Heritage Advisory Committee

2016/07/12

- 1. CALL TO ORDER
- 2. APPROVAL OF AGENDA
- DECLARATION OF CONFLICT OF INTEREST
- 4. MINUTES OF PREVIOUS MEETING
- 4.1. Approval of Minutes of June 14, 2016 Meeting
- 5. DEPUTATIONS
- 5.1. Malton Infill Housing Study Jordan Lee, Planner, Development and Design
- MATTERS TO BE CONSIDERED
- 6.1. Request to Alter 1011 Old Derry Road (Ward 11)

Appendix 4

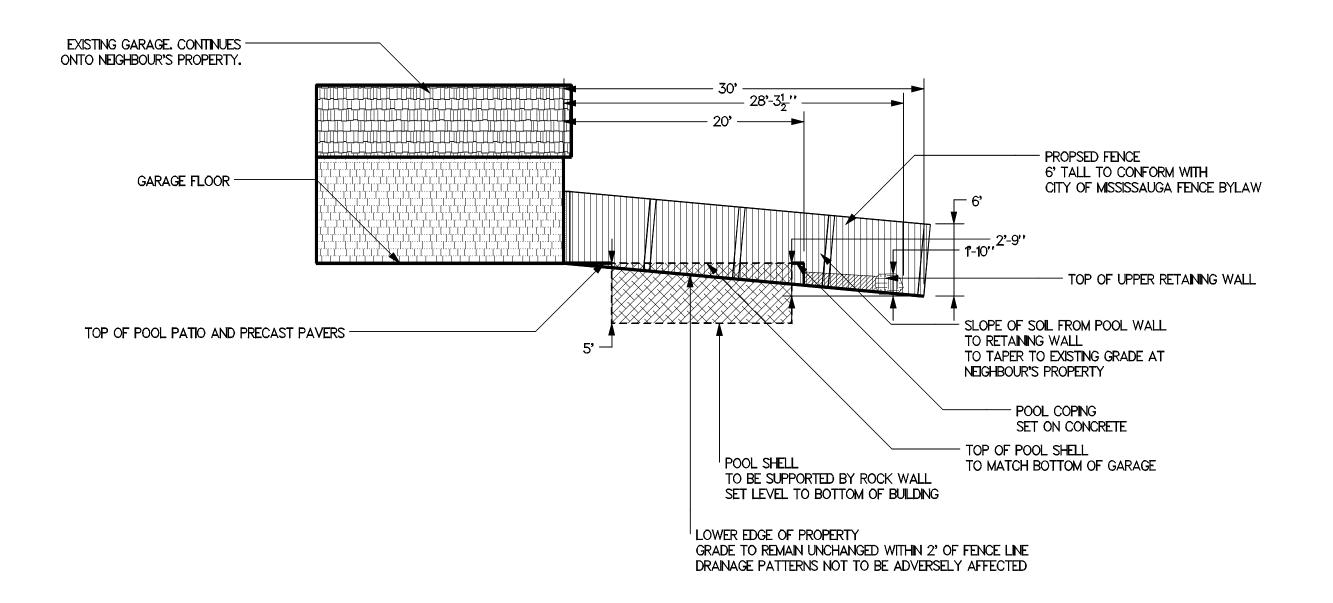
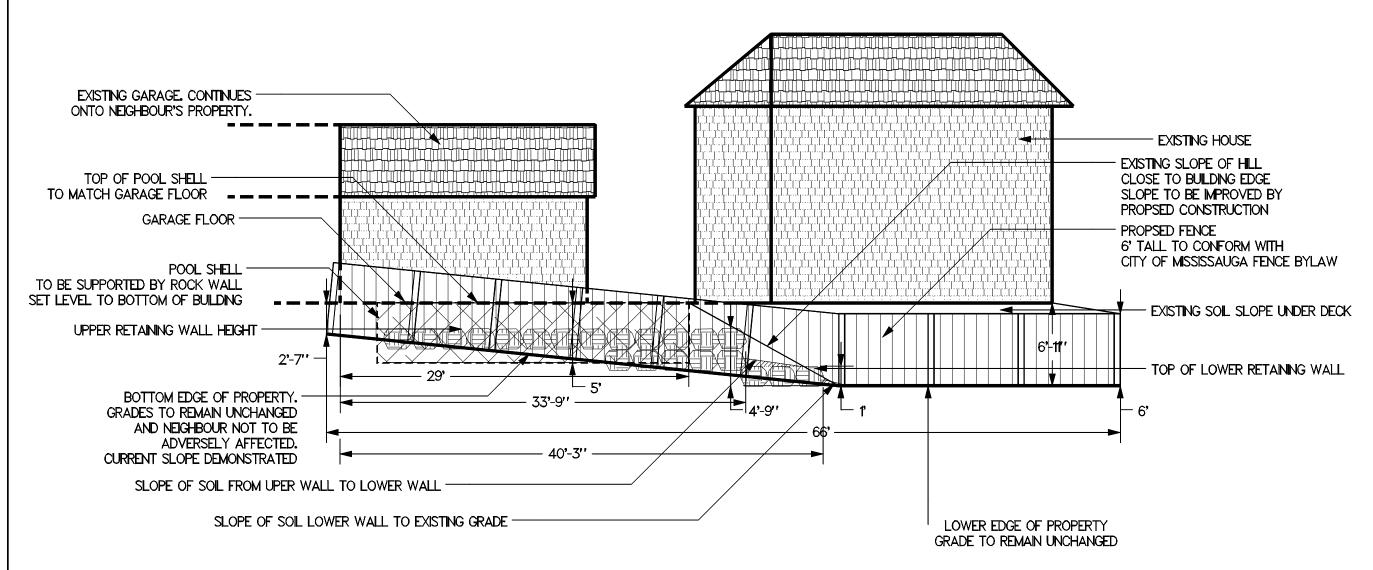
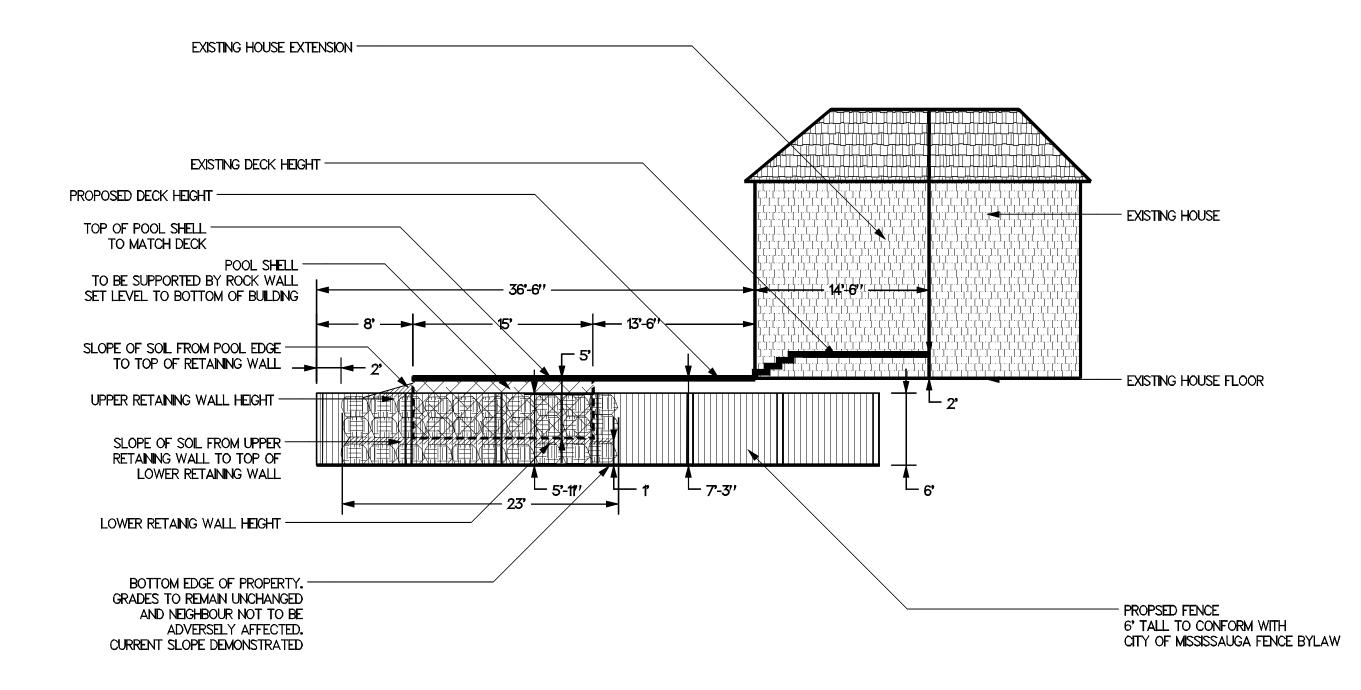
Plantings are proposed for privacy and to mitigate the appearance of the armour stone wall. Additionally, a six foot (1.8 metre) wood board on board fence is proposed on the north and west sides of the property. The chain link fence on the east side would remain, according to the site plan drawings; (the section drawing suggests a different "proposed fence" on the east side).

With its extensive built form and hardscaping, the proposal does not comply with the plan's Heritage Character Statement. Additionally, the built form proposed – the armour stone wall – is not vernacular, nor is it compatible with the scale, materiality and massing of landscape features within the district character.
Impact to the immediate streetscapes	Because the property drops significantly to the rear and due to the existence of the residence and garage, the proposal would not be visible from Old Derry Road. Currently the rear yard is visible from Pond Street. The guidelines permit privacy fencing when not visible from the public realm. If compliant fencing is installed (to be discussed below), the proposal would be visible from Pond Street.
Impact to abutting properties	The proposal would be visible to the abutting properties. With the significant grade changes, the pool would sit above the northern and western fence lines, creating an overlook situation on abutting properties.

Overall, the main concern is the armour stone retaining wall. It is not compatible with the character of the neighbourhood and greatly alters the existing topography. While plantings and fencing may minimize the appearance at some point in time, it will take time for plantings to have the desired camouflaging effect. Additionally, plantings and fencing are easily reversed. They may be removed by a future owner, exposing the large wall. A sense of stewardship should prevail in consideration of the long term negative impact of this proposal on the HCD.

For all of the above stated reasons, Heritage Planning staff recommend that the proposed changes not be approved.

Window recommendation:

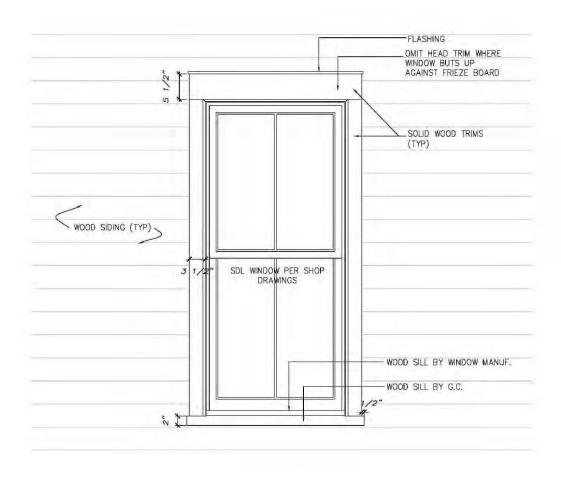
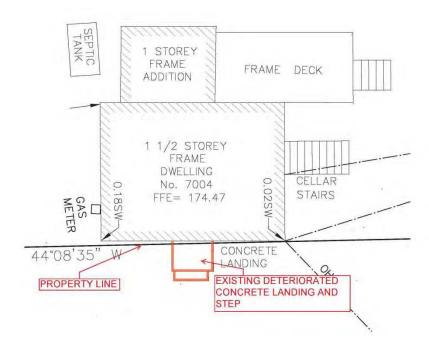
All of the windows on the existing building are inappropriate recent replacements and should be removed. The associated trims are also recent, poorly constructed and detailed and do not reflect typical 19th century methods or appearance. Their lack of flashing or proper installation to prevent water penetration is highly problematic. These should also be removed. In their place new double hung windows, either painted wood or vinyl with the appearance of painted wood should be installed. New trims, either painted wood or maintenance-free material painted to look like wood, should be installed as per the following detail.

- 1. No simulated dividers be employed on the windows
- 2. The proposed replacement door be simplified
- 3. Any repairs made to the original siding match the original material and dimensions
- 6.3. Request to Alter 7005 Pond Street (Ward 11)

Front Door:

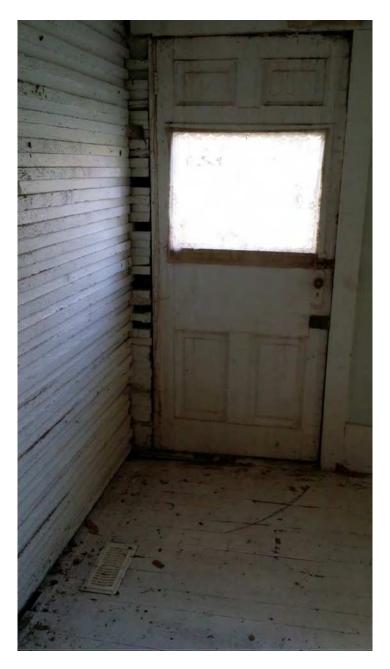
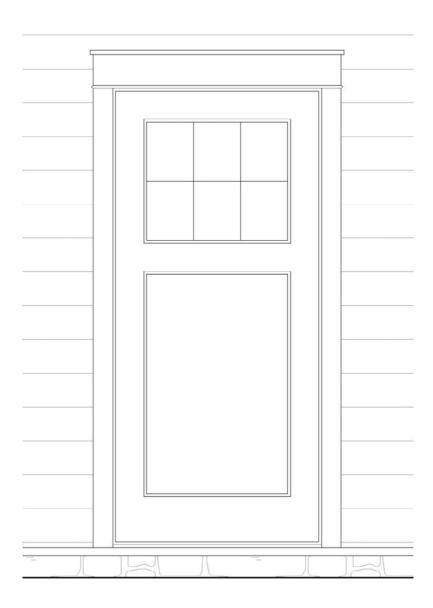
The existing front door is very likely not original, unattractive and not in good condition. There would be insignificant heritage value in its retention. It's replacement with a new wood door (and associated jamb) as shown in the detail below be appropriate.
